**RE: Submission in response to Modification #2, Yanco Delta Wind Farm (SSD-41743746)**

Figure 1: Proposed disturbance footprint from YDWF transmission line in Modification 2 overlapping with DWF proposed upgrades to part of McLennons Bore Rd. The modification tower locations have been estimated based on the publicly available information.

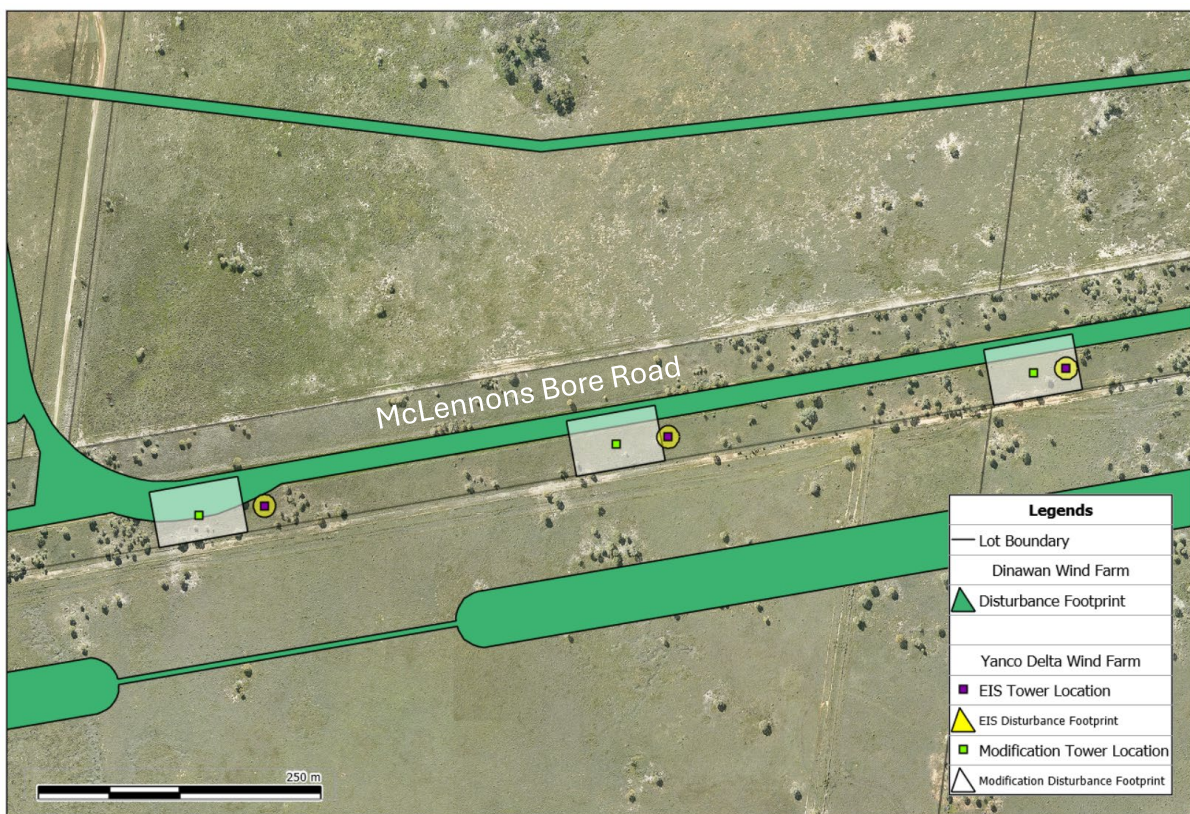
Spark Renewables notes that the originally approved transmission line footprint for YDWF along McLennons Bore Road was materially smaller than the footprint now proposed under Modification 2. Further, Modification 2 contemplates substantially larger construction work areas (from “10 metre radius around each pole, 400 metres apart” to “a 50 metre by 80 metre construction area”) and indicates that “partial short-duration closures” or “full closures of McLennons Bore Road” may be required during construction, with arrangements to be confirmed during detailed design.

McLennons Bore Road is a key access route for DWF, including for over-size over-mass and heavy vehicle access. Spark Renewables is concerned that the modification material does not yet provide sufficient clarity regarding the likely extent, duration and practical implications of works within the McLennons Bore Road corridor, including any potential impacts on road pavement, access continuity and overlap with the DWF development footprint associated with proposed road upgrades (examples are shown in Figure 1 and Figure 2). As currently described, those matters make it difficult to fully assess the implications of the proposed modification on DWF.

- further detail regarding the nature and extent of the proposed construction footprint within the McLennons Bore Road corridor;
- further clarification regarding the likely timing, duration and traffic implications of any road closures, restrictions or detours;
- consultation with Spark Renewables during preparation of the Traffic Management Plan and any other relevant management plans dealing with McLennons Bore Road; and
- a condition of consent requiring consultation and coordination between the proponents in relation to access, road occupancy, traffic control measures and timing of works where those matters may affect DWF.

Figure 2: Proposed amendments to the approved YDWF infrastructure causing interactions with DWF access routes. The modification tower locations have been estimated based on the publicly available information.

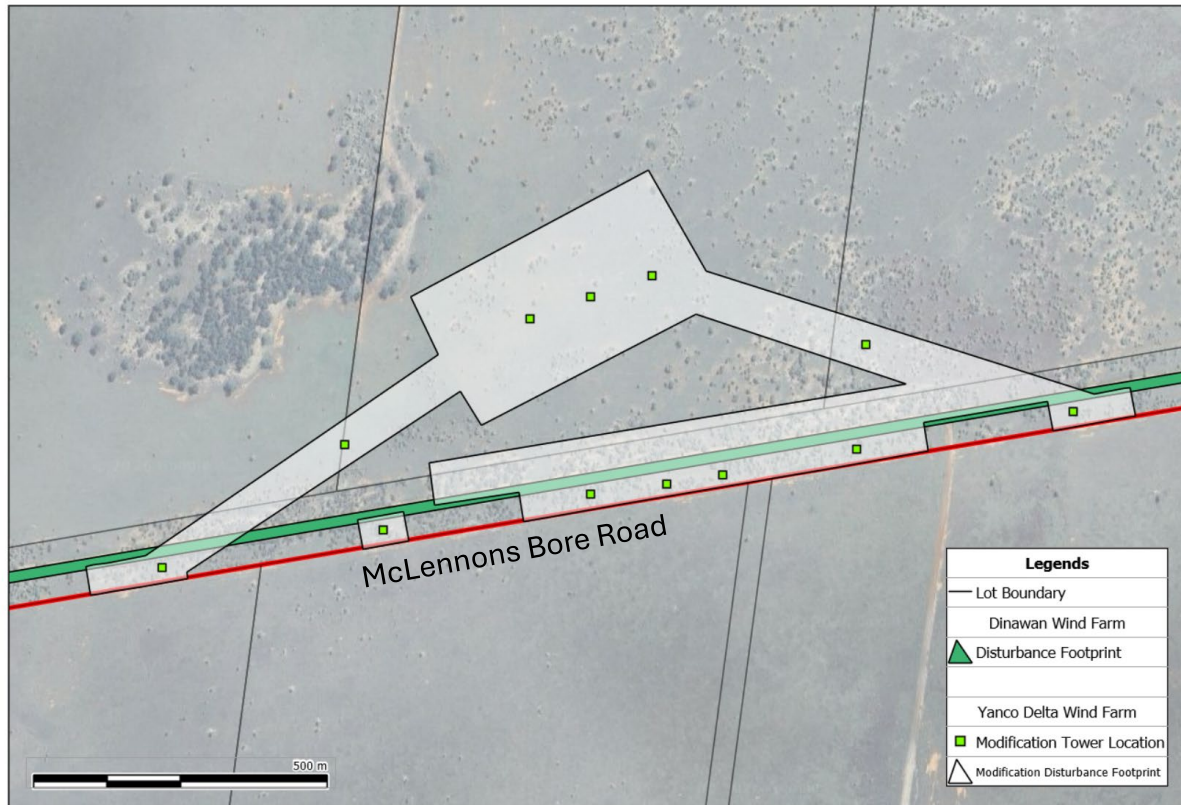
The Modification 2 has not taken into consideration the DWF site access points along McLennons Bore Road when proposing alternative transmission tower locations. Origin proposes an amended disturbance footprint that overlaps with the development footprint for DWF. An example is shown in Figure 2 (see western-most YDWF Modification Tower Location).

**Spark Renewables requests that this transmission tower location be reviewed as part of the assessment of Modification 2 and that minor refinements and tower micro-siting be considered to avoid overlap with DWF access points and the swept path allowed for in the development footprint.**

*Figure 4: Disturbance footprint across Goolgumbbla Road*

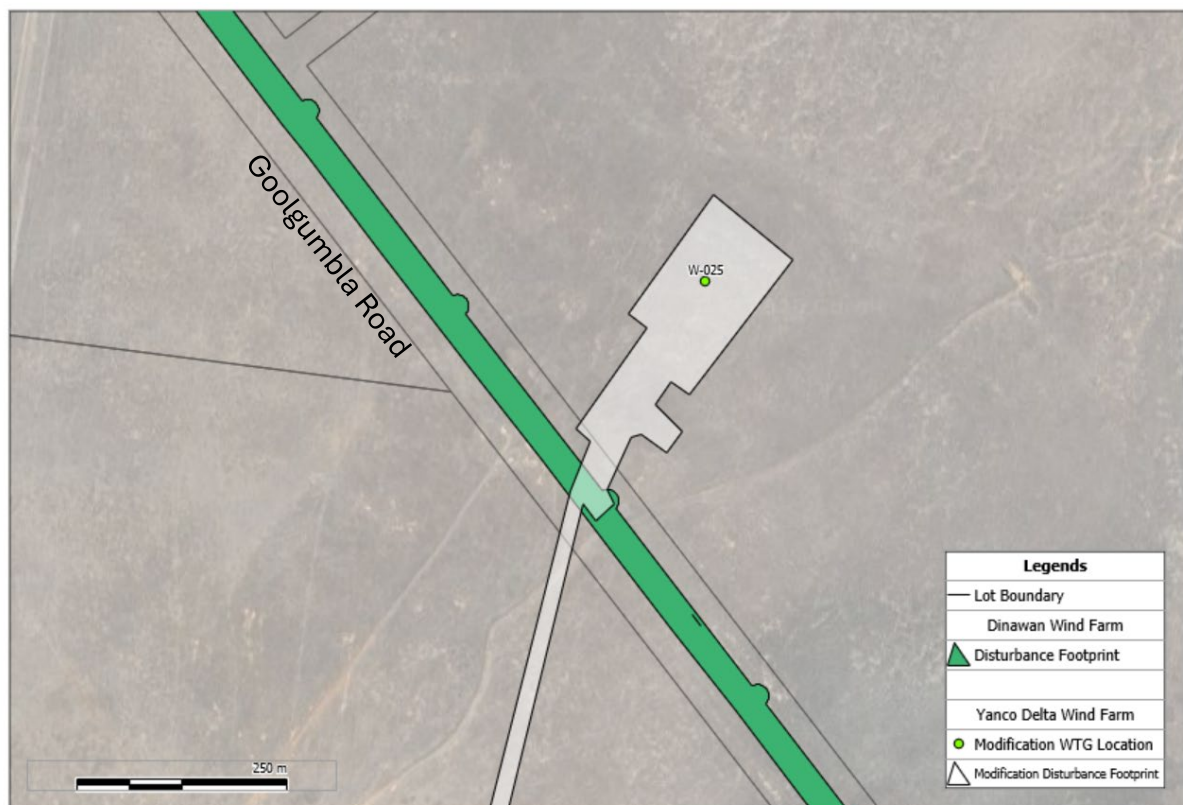
Modification 2 does not identify use of Goolgumbbla Road for YDWF-related traffic. DWF relies on use of Goolgumbbla Road to access the western portion of the DWF site. We note that the YDWF revised disturbance footprint includes an access point disturbance polygon onto Goolgumbbla Road southwest of YDWF turbine W-025. The nature of the impact of Modification 2 on Goolgumbbla Road is unclear and, in the absence of additional information, Spark Renewables requests that access along Goolgumbbla Road is not inhibited by disturbance related to YDWF at this location.

We note that YDWF's wind turbine W-025 is located north of Goolgumbbla Road. We request clarity on how this wind turbine will be accessed. We assume it will be accessed via the YDWF disturbance footprint by crossing Goolgumbbla Road. If so, crossing Goolgumbbla Road should be coordinated with the DWF.
